PETITION FOR LEAVE TO AMEND

The application (File No. BPH-92050242) of The Fidelio Group, Inc. for a construction permit for a new FM broadcast station to operate on Channel 282B in New York, New York is hereby amended to substitute the accompanying engineering materials for the corresponding materials in the application as originally filed.

ENGINEERING EXHIBIT

Amendment to Application for Construction Permit

FIGURE 1 (AMENDED) ANTENNA SYSTEM ELEVATION PLAN

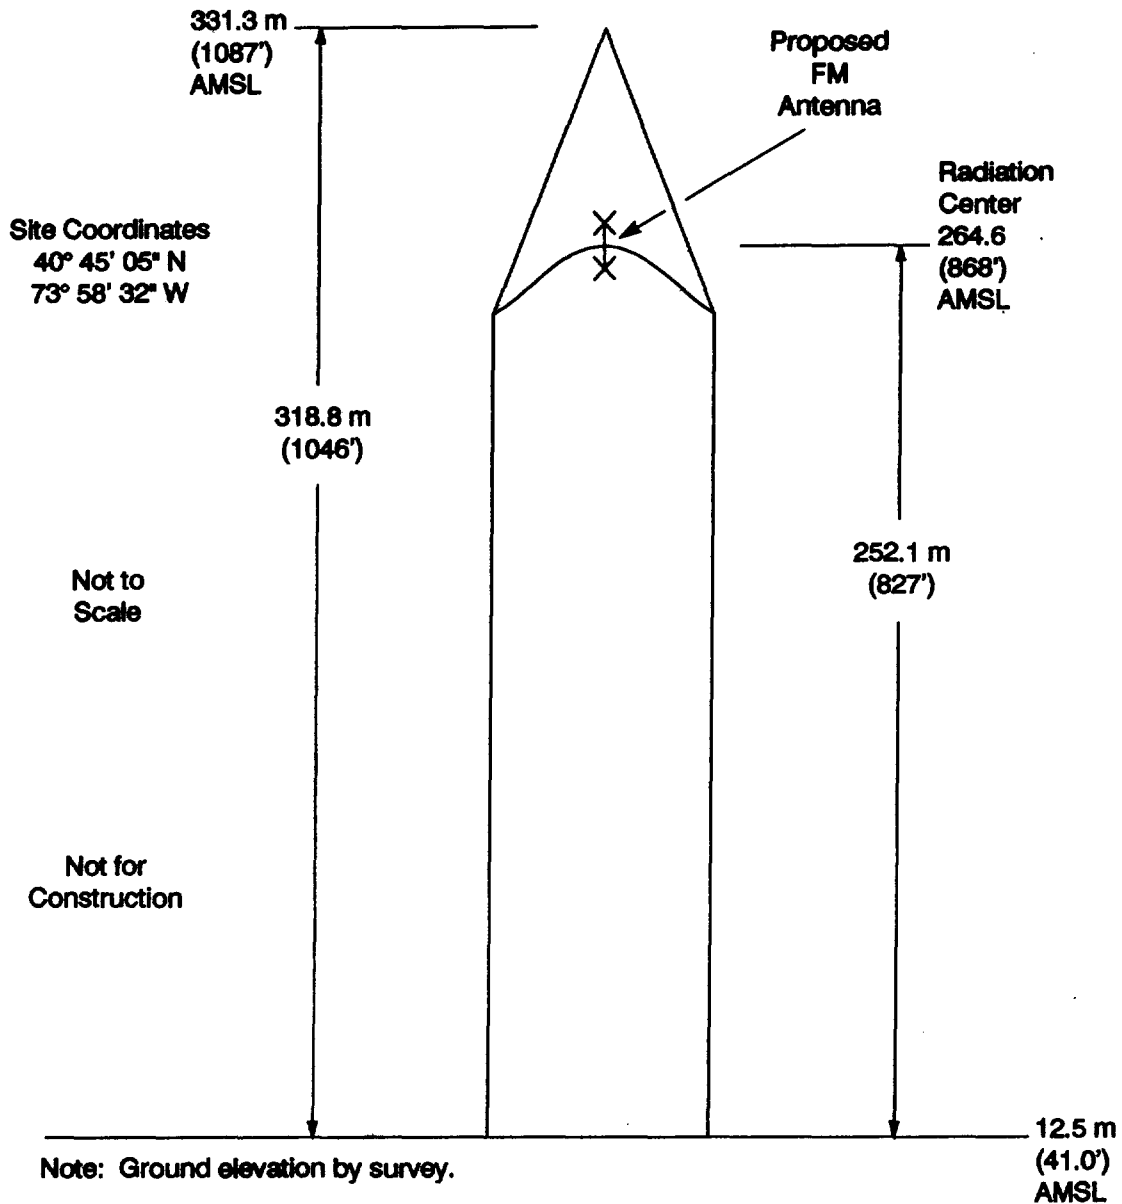
The Fidelio Group, Inc. hereby proposes to amend its Application for Construction Permit filed May 1, 1991 (FCC File Number BPH-910502MQ) to specify a different antenna height above ground and average terrain with a corresponding decrease in power.

When the original application was prepared, Fidelio was advised by representatives of the Chrysler Building that its antenna would be 213 meters (700') above ground. Recently, Fidelio learned that the antenna would instead be located at 252 meters (827') above ground, along the spire of the building. Fidelio has prepared this amendment to specify the modified antenna height and surveyed ground elevation. The proposed power is reduced to maintain equivalent 60 dBu coverage to that shown in the original application. Further, 1990 Census data (not available when the original application was filed) is included herein.

Attached hereto are only the portions of the application which have changed: FCC Form 301, Figure 1 (the Antenna System Elevation Plan), and Statement D (Environmental Considerations. All other figures, statements and tables remain unchanged. With respect to coverage, the proposed 60 dBu coverage (amended) is within 0.1 kilometers of that shown in the original application in all directions. This change is insignificant, is beyond the resolution of the base map scale, and causes no effective change in the proposed coverage. The proposed 70 dBu coverage will be within 0.5 kilometers of the originally proposed coverage. This change cannot be resolved on the base maps, and will cause no material change in the percentage of area or population of the principal community which receives 3.16 mV/m coverage. The proposed facility will continue to satisfy the requirements of Section 73.213 of the FCC Rules in that its 60 dBu contour will extend no further than the existing WNCN facility towards any short spaced stations. For these reasons, new coverage and coverage comparison (73.213 study) maps are not supplied as they would be superfluous. Such maps will be supplied upon request.
